RE: ENGINEER'S CERTIFICATION FOR McKINLEY MIDDLE SCHOOL(G-17/D19)
ENGINEER'S CERTIFICATION STATEMENT DATED 12/11/98.

DRAINAGE INFORMATION SHEET

RE: Grading and Drainage Plan for McKinley Middle School (G17/D19) Submitted for Grading Permit and Building Permit Approval, Engineer's Stamp Dated 3/20/97.

TITLE:		McKINLEY COMMUNITY CENTER GRADING PLAN - PHASE 3	
Design Review Committee	City Engineer Approval	MO/YR	MO/YR
City Project No.	4875.92	Zone Map No.	G-17
		Sheet	Of
			C-1

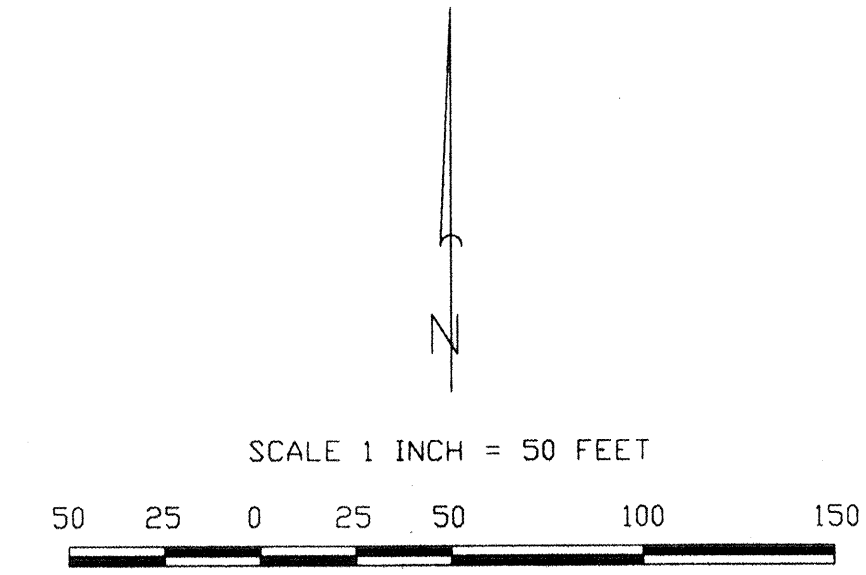
Contours?
